Khangela Emoyeni Wind Energy Facility (WEF) – Phase 2

Draft Amendment Report

Reference: 509161
Revision:0

Submission date: 2020/09/07

Figure 12: Proposed layout relative to the sensitive areas for bats (IWS, 2020)

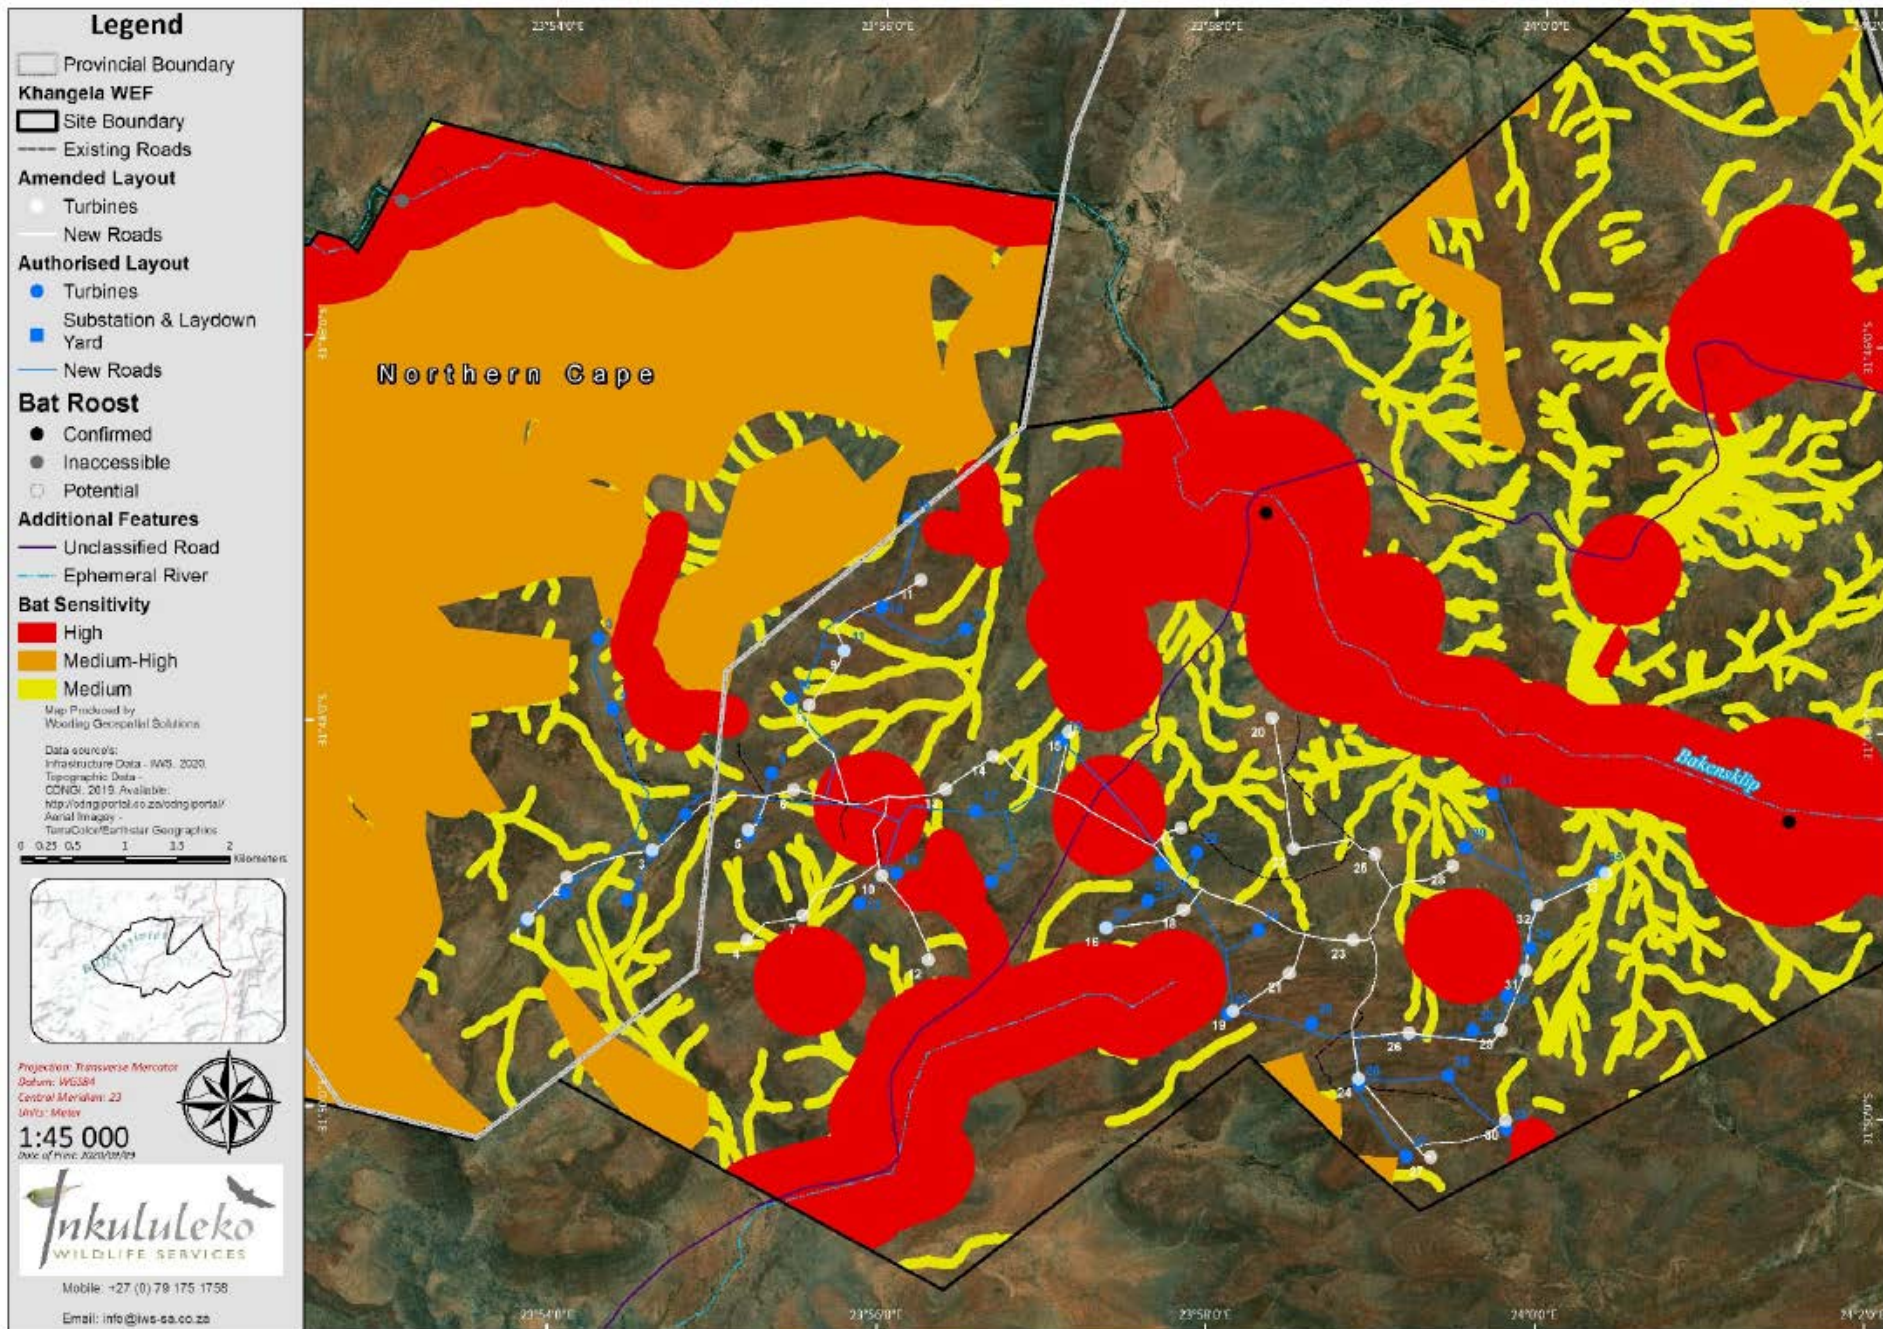
The description of each class used in the sensitivity map (Figure 12) is presented in Table 13. Based on the most recent pre-construction bat monitoring guidelines (Sowler *et al.* 2017 and MacEwan *et al.* 2020), the buffer around high sensitive ephemeral streams and dams has been increased from 50 m to 200 m. In accordance with this, the proposed layout ensures the avoidance of the high sensitive areas. No turbines encroach into high sensitive habitats and/ or buffers; however eleven turbines encroach into medium sensitive habitats and or buffers.

- Report any new discovered roosts and incorporate their protection into the WEFs adaptive management plan.
- Prioritise dropping turbines in closest proximity to High, Medium-High and Medium sensitive areas (in descending priority) and/or on the periphery of the WEF (to reduce its overall footprint), if fewer than 33 turbines are developed.

Figure 16: Viewshed (top map showing authorised 2018 layout, bottom map showing amended 2020 layout) (Oberholzer and Lawson, 2020)

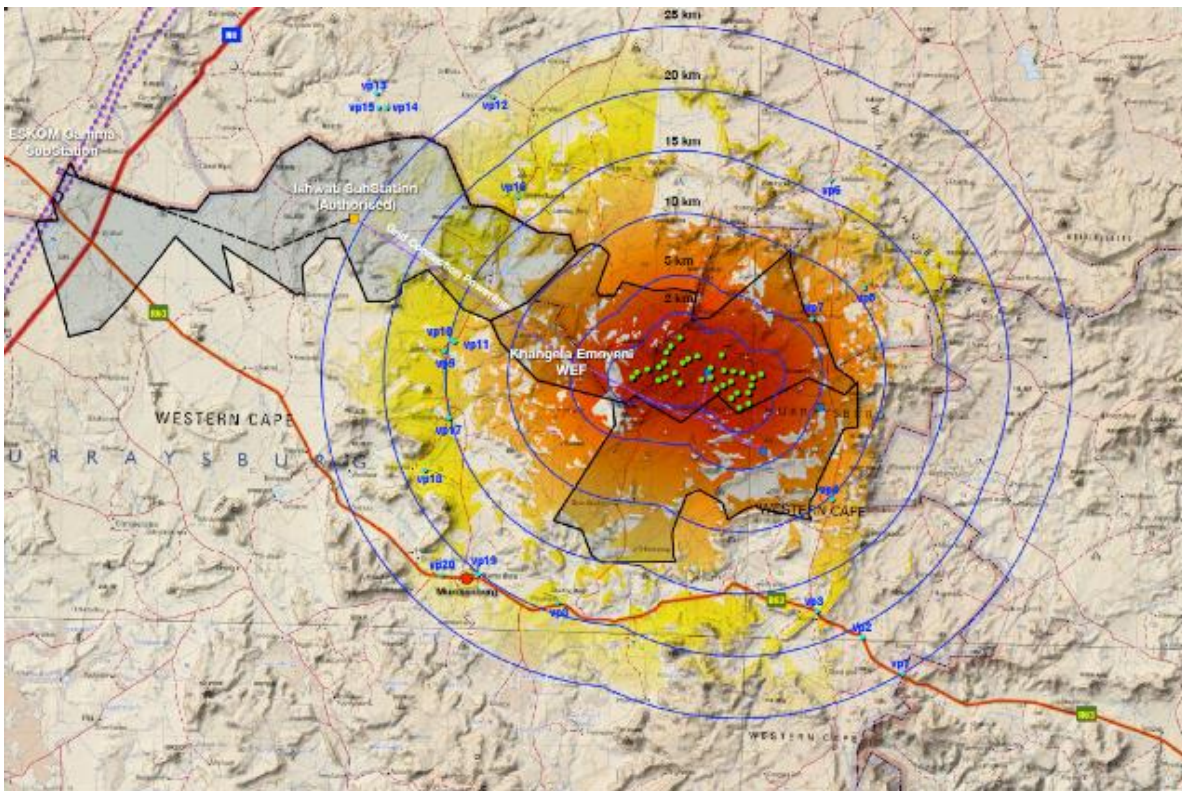
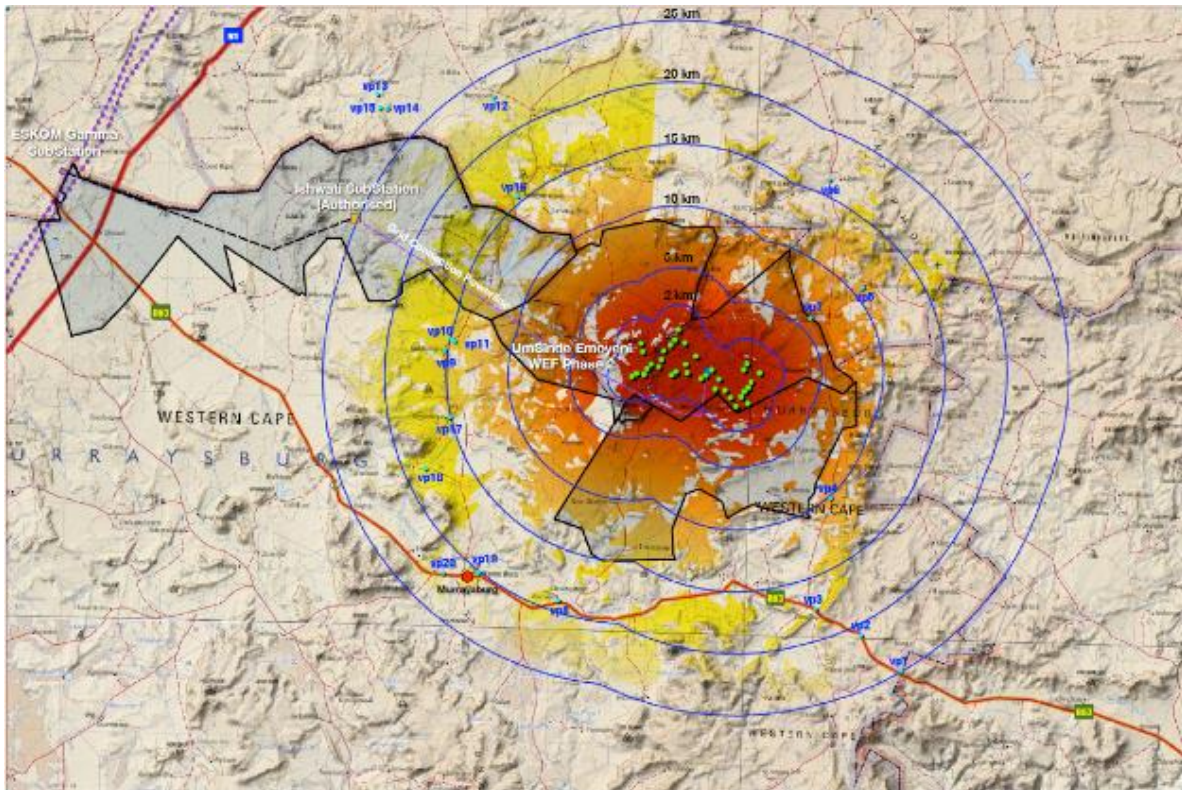
The layout of the turbines has also slightly changed. The visual informants to determine sensitivity are indicated in Figure 17, and have been taken into account in the authorised and current layouts.

In the previous amendment of 2018, the turbines were moved further north, away from the Trouberg sensitive receptors. Distances from sensitive receptors increased in some cases, and with the fewer turbines, the viewshed would be less extensive, particularly towards the south. A comparative assessment of the previous (2018) and current (2020) viewsheds, shown in Figure 16, indicates that the zone of visual influence would hardly change. In reality, the increased size of the turbines would probably only be noticeable within a range of about 5 km. Figure 18 and Figure 19 show a photomontages of the amended layout from various viewpoints.
